Item 1

4 Wood Street, EASTWOOD

Demolition, new two storey dual occupancy (attached) with a swimming pool.

City of Ryde Local Planning Panel Report

Figure 8: Plan depicting primary road frontage of 10.7m in red.

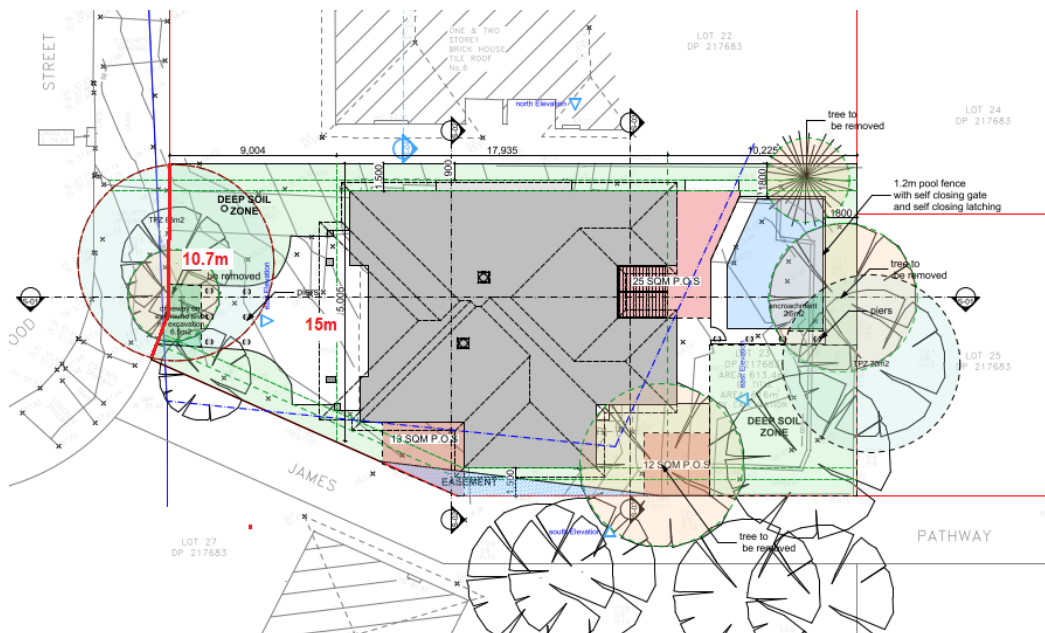
The development contravenes Clause 4.1B(2)(b) of RLEP 2014. Clause 4.1B(2) relates to minimum lot sizes for dual occupancies and prescribes a minimum primary road frontage of equal to or greater than 15 metres for development on a lot in the R2 Low Density Residential zone for the purpose of dual occupancy (attached).

The subject site has a road frontage width of 10.7m at the front boundary which results in a variation of 28.67% (see **Figure 8**). The site is located at the start of the curve of the cul-de-sac for Wood Avenue. The front boundary is part of an arc which is 10.66 metres in length. It is noted that the site has a width of 15 metres at the proposed front building line.

Figure 9 – Site plan depicting site width at front building line

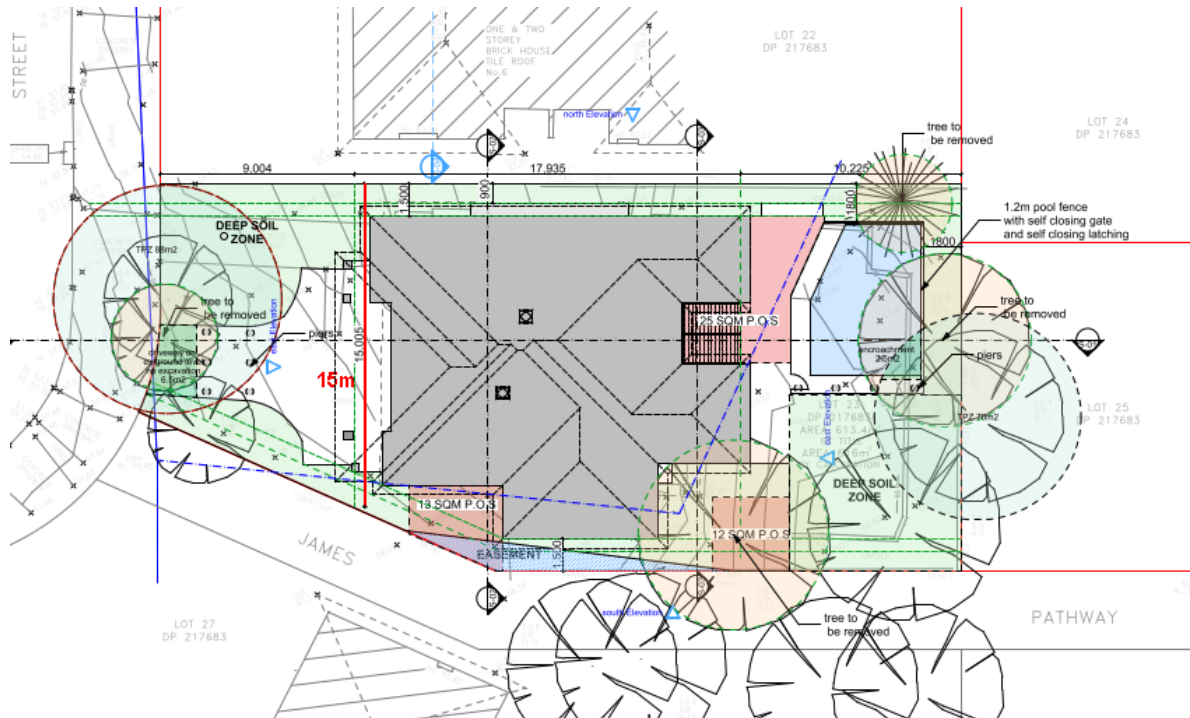
Whilst the minimum required frontage width of 15 metres is not complied with at the front boundary, the 15 metre width is achieved at the proposed front building line, given that the site width increases from front to rear (see **Figure 9**).

Agreed – the non-compliance is due to the unique tapering of the site to allow for a side public pathway which provide access from Wood Street to Vimiera Road. (See **Figure 9**).

Figure 11: 1st floor plan with void area with side and rear windows. This allows sunlight to filter through to the rooms below.

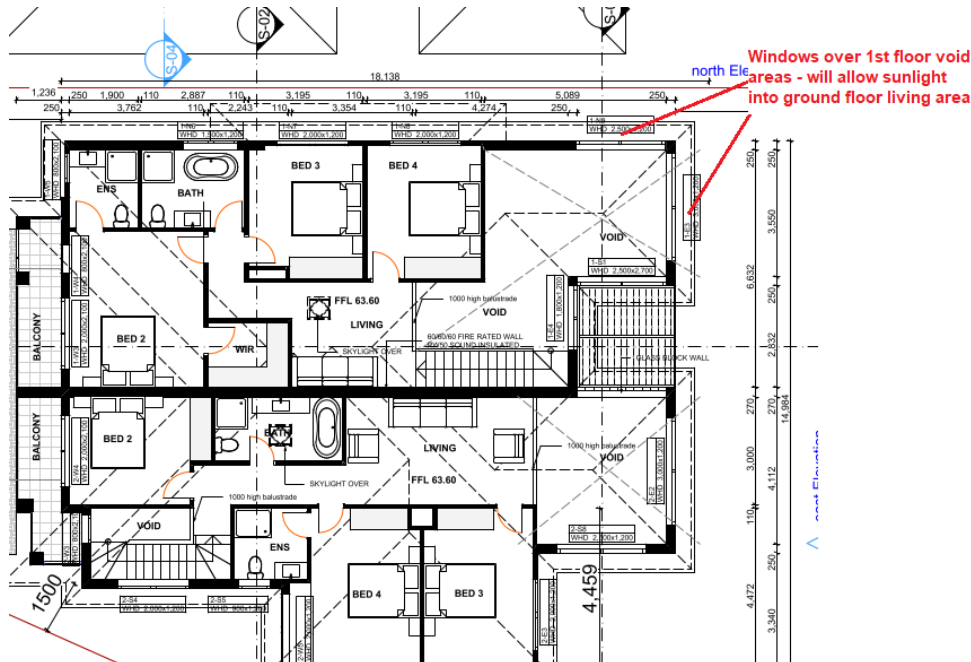
The proposed design variation is considered acceptable. Whilst the 4m setback is not provided along the northern elevation, the intent of this clause is to provide good solar access to the dwelling living area, which is achieved for Unit 1 which is adjacent to the northern boundary.

It is also noted that the ground floor north facing windows are not able to achieve the required solar access due to the orientation of the land, being east-west. The adjoining northern property is a 2 storey dwelling. This dwelling is in line with the proposed dwelling and due to the orientation currently overshadow the subject site. This is unavoidable however the applicant has provided front and rear windows off these rooms which helps to provide solar access to the rooms. Furthermore, the rear family room has a 1st floor void over the room. The 1st floor void area has a side and rear window which will allow sunlight into the ground floor family room.

Whilst it is possible to amend the design to have the family room moved adjacent to Unit 2's family room, thereby creating a greater side setback, this would have resulted in acoustic concerns with each of the family living areas being side by side.

The application has been amended to reduce the size of the windows off the void areas. No access is available to these windows and **Condition 5** has been imposed stating the first floor void areas are not to be converted to floor space area.

Figure 13: Amended design with the windows over the 1st floor area reduced in size. The windows will still provide sunlight to the ground floor family room but is now less dominant.

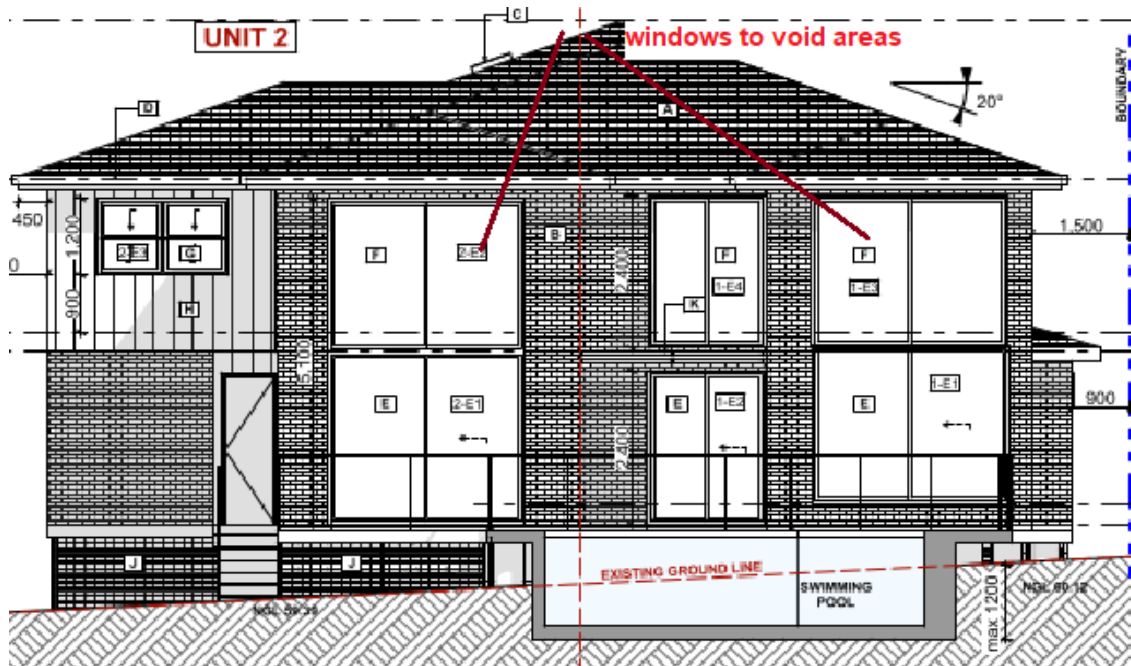
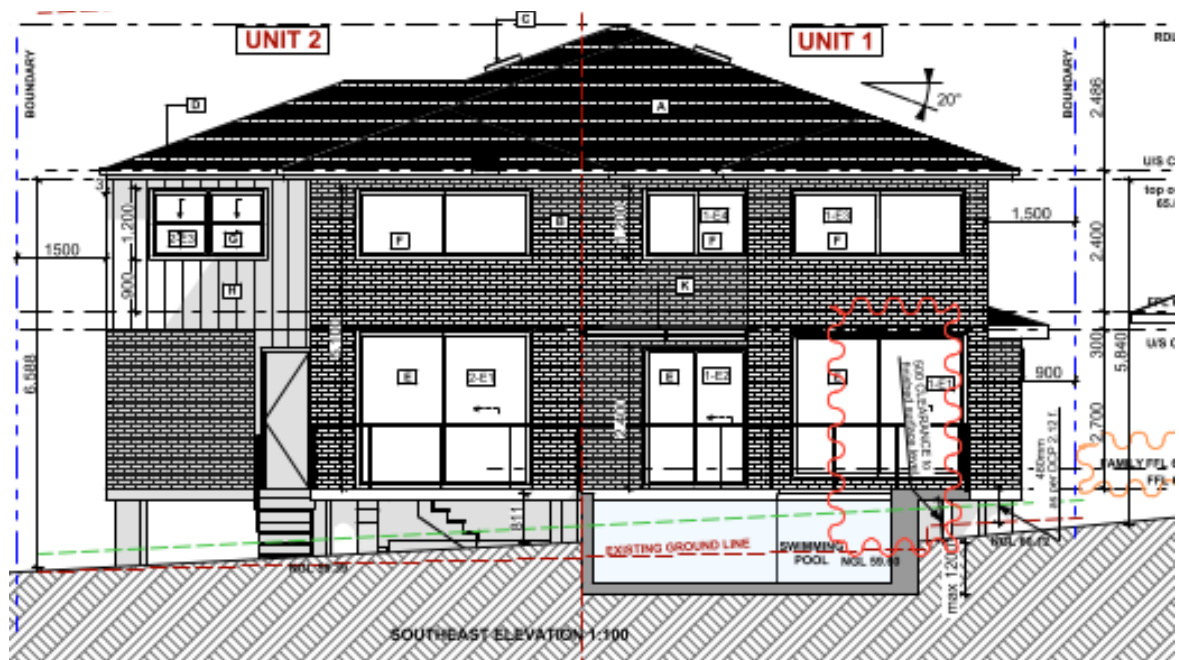
A comparison of the original windows size to the reduced windows is shown in **Figures 12 & 13**.

Figure 12: Original Northern elevation illustrating the window over the void area. This will help provide solar into Unit 1 living area

Figure 14: Site inspection photo of the rear boundary, with well established landscaping at 89 Vimiera Road and area for landscaping along the perimeter of the site.

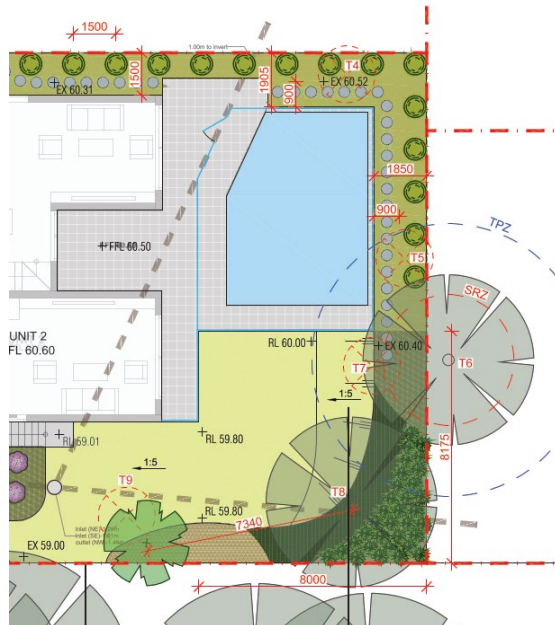
Clause 2.9.3 requires a rear setback of 9.25m (based on 25% of the site length). The proposal will have a rear setback of between 6.3 to 8m from the rear deck area to the

rear boundary. It should also be noted that the swimming pool be setback 2m from the rear boundary. The proposed variation is considered acceptable as sufficient separation is provided to prevent any overlooking to the rear yard of the adjoining property (89 Vimiera Road). 89 Vimiera Road rear boundary is well screened with landscaping (as shown in the photo below) and will the addition of planting along the rear boundary as proposed in the submitted landscaping plan, the variation to the rear setback area can be supported.

Figure 16: As the deck is elevated, Condition 34 has been imposed requiring the deck to be set back 1.5m off the boundary and a 1.8m high privacy screen provided along this elevation.

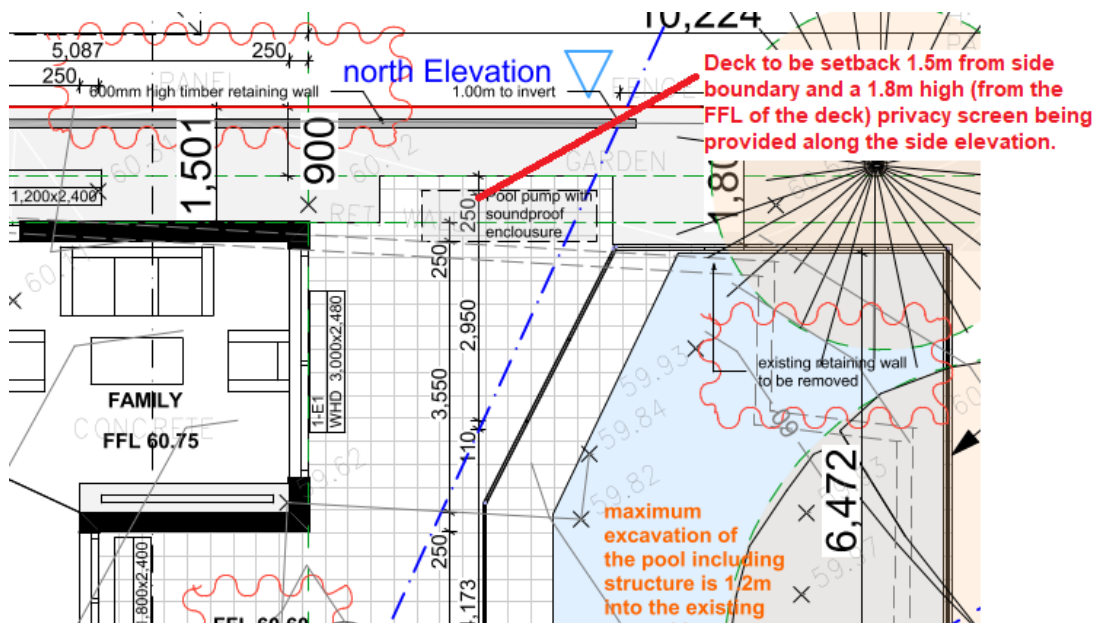
Note: It should be noted whilst the proposal complies with the side setbacks, due to the dwelling being elevated (flooding requirement), the rear deck area of Dwelling 1 has the potential to overlook into the adjoining property – 6 Wood Street rear yard area.

Condition 34 has been imposed requiring the side deck being setback 1.5m off the side northern boundary and a 1.8m high privacy screen being provided along the side elevation of the rear deck area, as shown below.
